MEMORANDUM

Re: **Concept Condominium Plat – Storage Shop USA – 7930 E. Frontage Road**
Parcel ID 104-04-22-07-053-000
Applicant & Owner – Greg Thomas – Storage Shop USA

A CONDOMINIUM PLAT

STORAGESHOPUSA - CALEDONIA

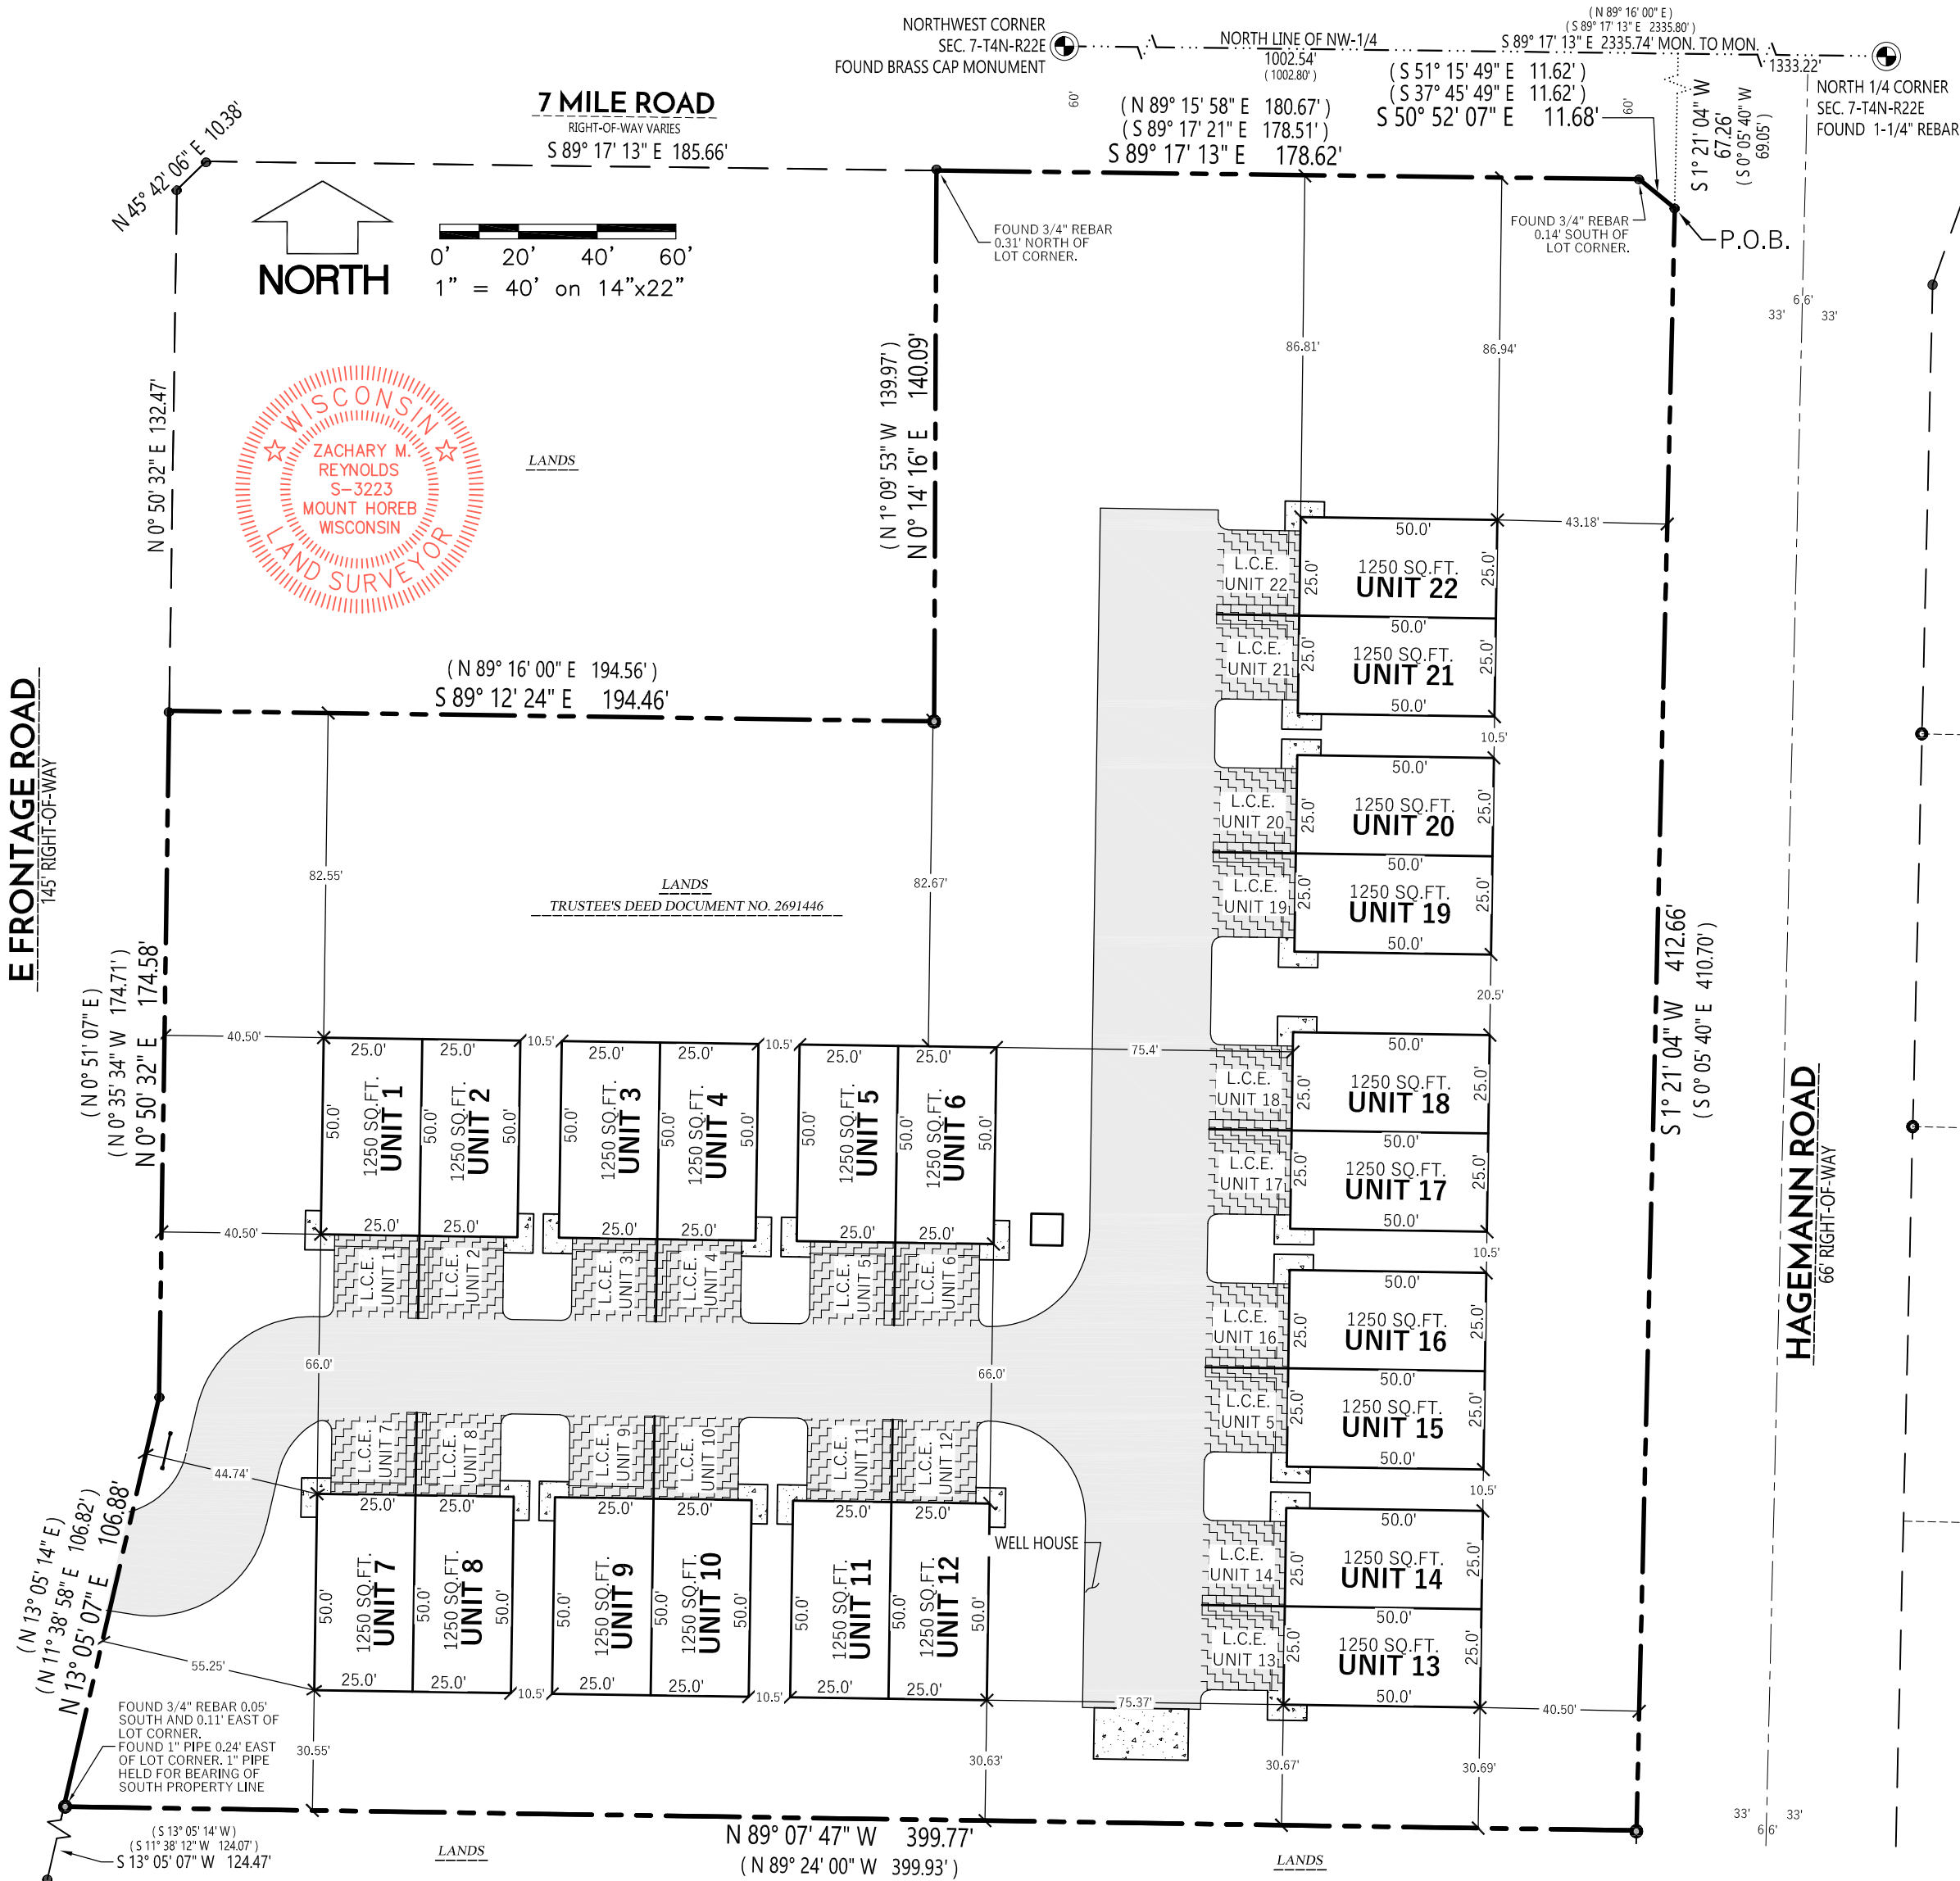
No access restriction shall be placed and shown along 7 Mile Road, the Northeast corner of the property, and Hagemann Road. It is recommended that No Access be placed in conjunction with the Wisconsin DOT along the E. Frontage Road as well, but this area is outside of Village Jurisdiction. In addition to the no access, a 25'x25' vision triangle shall be placed at the NE corner of the property.

The proposed commercial Condo Plat as presented shows multiple bearings with 2 corrective or alternative bearing angles and distances. Staff would like clarity on these bearings and to ensure the appropriate legal description of the property is being used to ensure no legal gaps are created as part of this Condo Plat. The coordinates shall also be placed on the Condo Plat for the Quarter Sections being referenced. Lastly, there is a minor error with the misplacement of the well house label that should be corrected along with a typing error in the surveyor's certificate calling out the "StorageSuiteUSA" rather than the StorageShopUSA being referred to.

6. Owner/Developer is required to record the Final Plat and provide the Village a digital copy prior to any Building Permits being issued.
7. Surveyor to update the Condo Plat to show name and ownership information on all lands within 100' of the subject property.

8. Surveyor to update the Condo Plat to show No Access along 7 Mile Road, Hagemann Road, and the E. Frontage Road as required by the WisDOT.
9. Surveyor to update the Condo Plat to show a 25'x25' Vision Triangle at the NE corner of the property.

10. Surveyor to Update the Condo Plat to include coordinates of the Section Corners and to clarify or correct the measurements provided for the bearings and distance measurements for this property.

11. Surveyor to update the Condo Plat to provide the corrections on the well house label and errors in the surveyor's certificate.
12. Owner/Developer to execute and record the Village approved revision of the declaration documents for the condominium in conjunction with the recording of the Final Plat.
